## Executive Director's Recommendation

Commission Meeting: July 11, 2019

<b>PROJECT</b> <b>New Master Clock Facility and Building Rehabilitation</b> US Naval Observatory 3450 Massachusetts Avenue, NW Washington, DC	<b>NCPC FILE NUMBER</b> 7995
<b>SUBMITTED BY</b> United States Department of Defense Department of the Navy	<b>NCPC MAP FILE NUMBER</b> 71.20(38.00)44956
<b>REVIEW AUTHORITY</b> Federal Projects in the District per 40 U.S.C. § 8722(b)(1) and (d)	<b>APPLICANT'S REQUEST</b> Approval of final site and building plans
	<b>PROPOSED ACTION</b> Approve final site and building plans
	<b>ACTION ITEM TYPE</b> Staff Presentation

Approval of Final Site and Building Plans

## Project Changes Since Concept Submittal

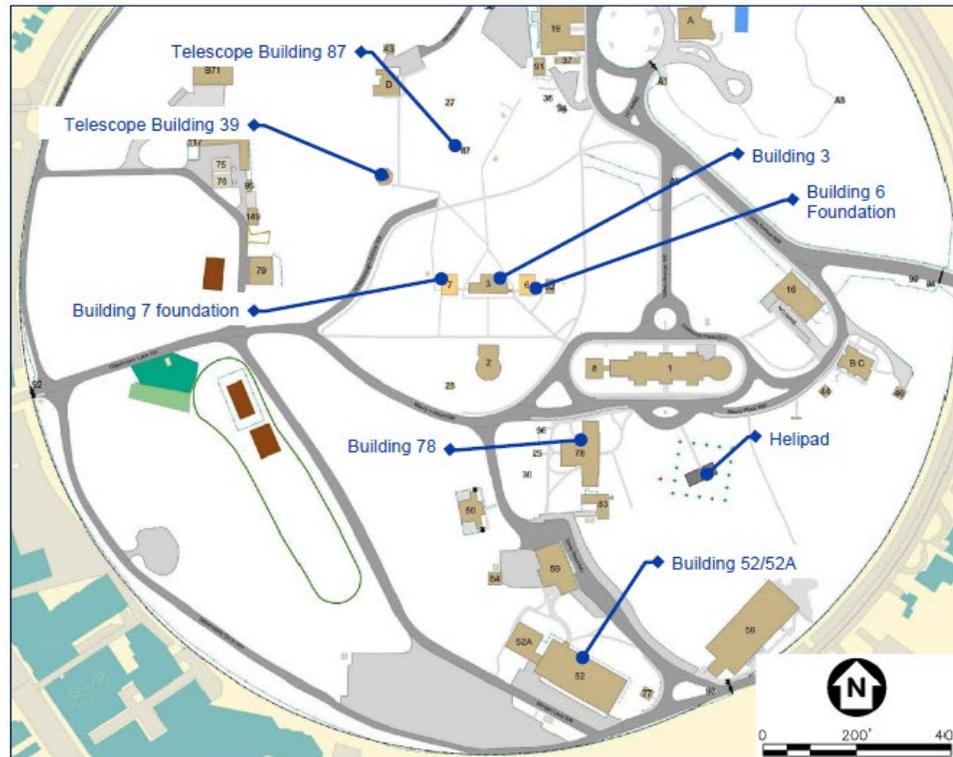
- **Removed Building 51 fence and gates, as no longer required**
- **Revised Building 78 elevator location and extended to roof, due to structural concerns with previous location and to meet the requirements of the program**
- **Removed bioretention basins near Buildings 52/52A and 78, as stormwater management solutions around Buildings 3 and 51 meet the requirements for the site**

## Observatory Center: Site Plan

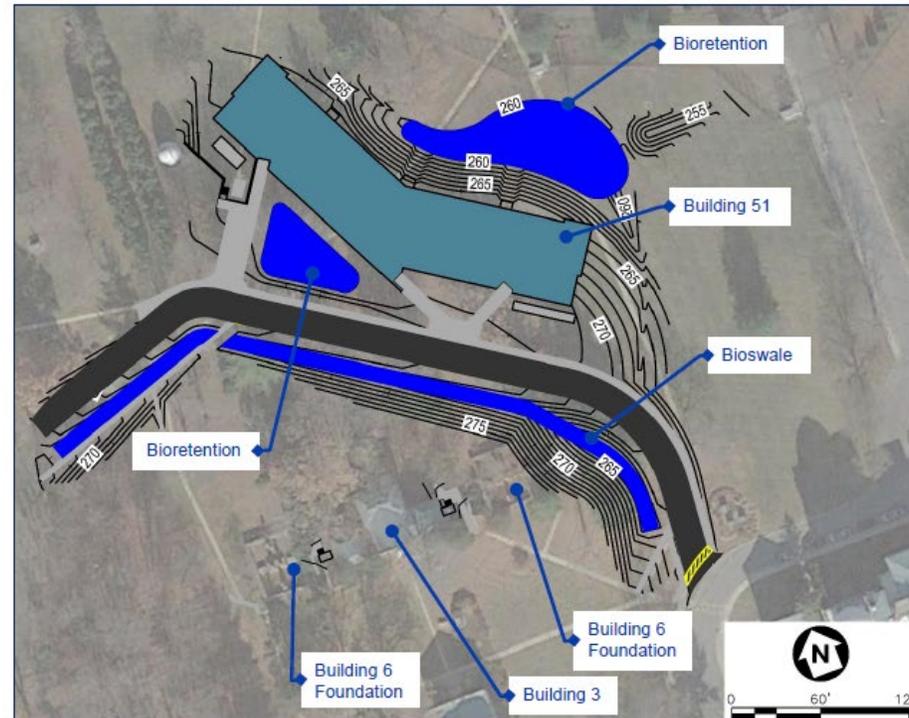
- **Location of Building 51 within the USNO is purposeful**

- As close to the center of the USNO as possible to minimize influences from surrounding urban activities
- Area and height requirements of new building are much greater than original building (Building 3)

- **Early design schemes placed building on axis with Building 3**

- Overwhelmed the historic structure and would destroy greater number of historic landscape elements

- **Preferred location**

- Impacted fewer historic landscape elements
- Eliminates the axial relationship between the old and new
- Comparison in scale with Building 3 is diminished
- Down slope of Building 3, allowing floor level to be lower and visually lessening building's mass
- Linear building plan broken in the center to follow existing contours and fit the building within the site constraints
